Summary of proposed amendments to the Central Business Zone based on the recommendations in the Height Standards – Performance Criteria Review (Leigh Woolley 2017)

Amendments:

Figure 22.6 View lines

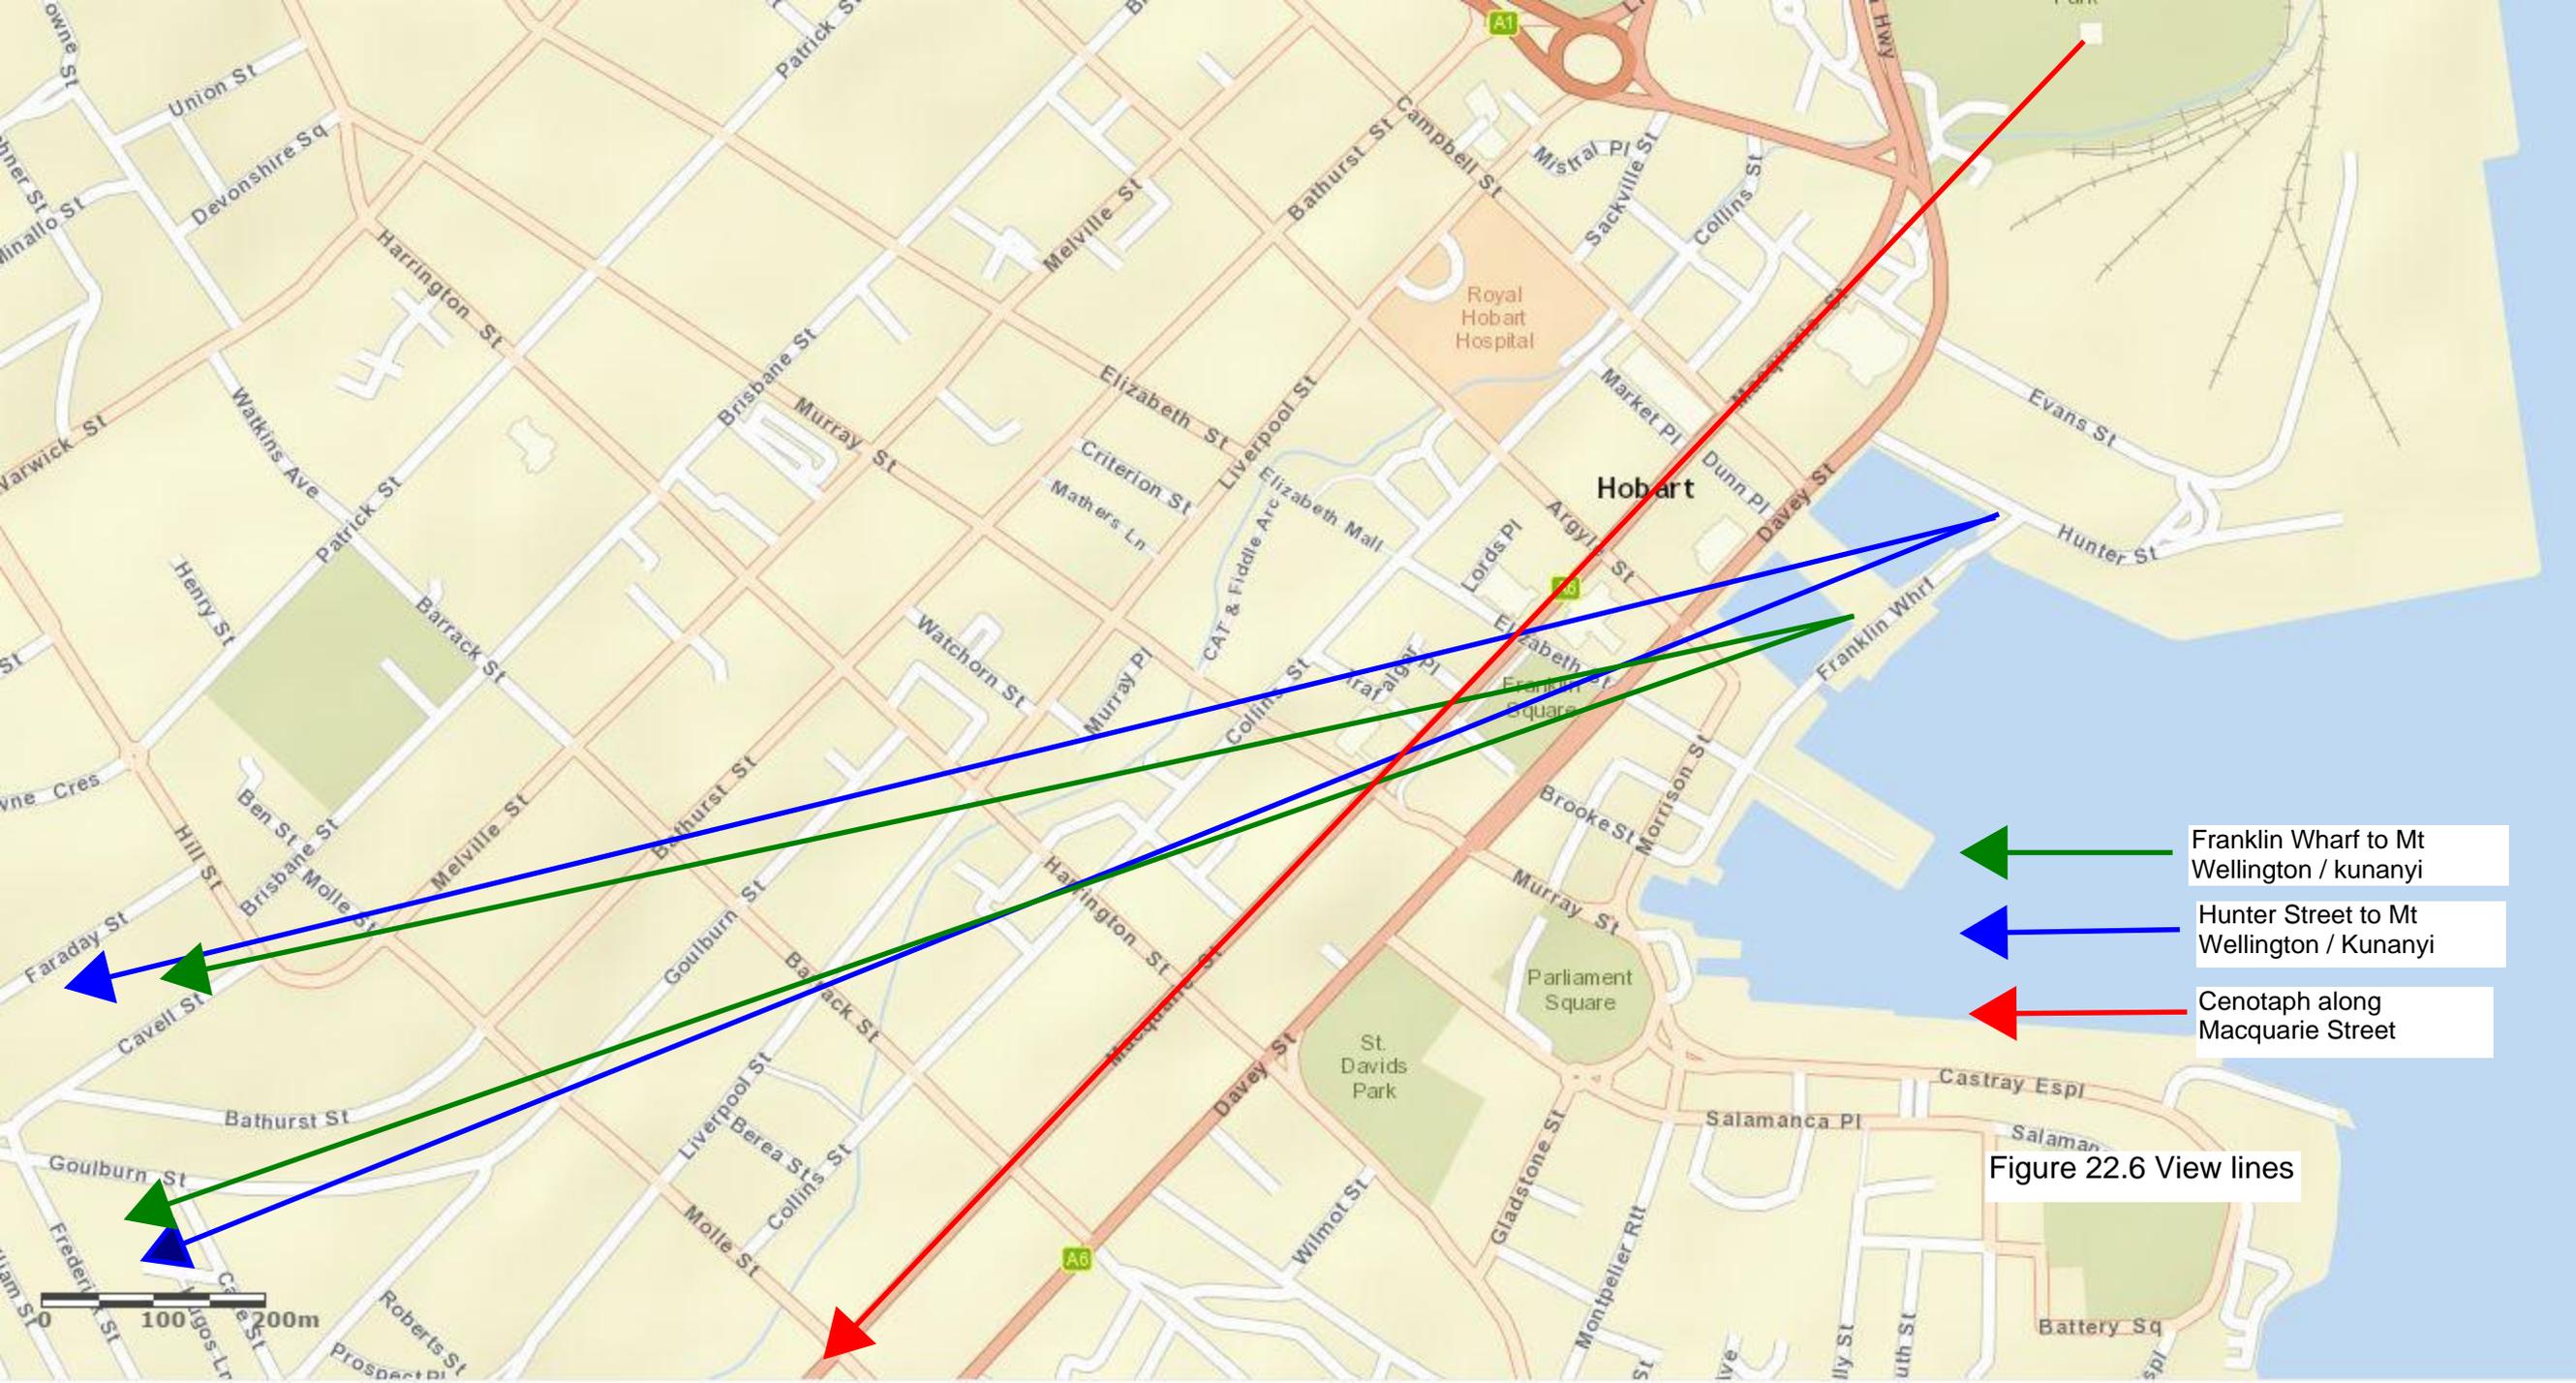
<p>and</p> <p>(iv) <u>it does not obscure or negatively impact on the view lines identified in Figure 22.6 or the landscape horizons to Mt Wellington / kunanyi and the Wellington Range from public spaces within the Central Business Zone; and</u></p> <p>(v) <u>it is consistent with the Desired Future Character Statements in clause 22.3.1; and</u></p> <p>(vi) for city blocks with frontage to a Solar Penetration Priority Street in Figure 22.2, the overshadowing of the public footpath on the opposite side of the Solar Penetration Priority Street does not unreasonably impact on pedestrian amenity; and</p> <p>(vii) <u>overshadowing of public open space does not unreasonably impact on the amenity of that space.</u></p>
<p>A2</p> <p>Building height within 10 m of a residential zone must be no more than 8.5 m.</p>	<p>P2</p> <p>Building height within 10 m of a residential zone must be compatible with the building height of existing buildings on adjoining lots in the residential zone.</p>

(viii) it does not obscure or negatively impact on the view lines identified in Figure 22.6 or the

landscape horizons to Mt Wellington / kunanyi and the Wellington Range from public spaces within the Central Business Zone; and

- Franklin Wharf to Mt Wellington / kunanyi
- Hunter Street to Mt Wellington / Kunanyi
- Cenotaph along Macquarie Street
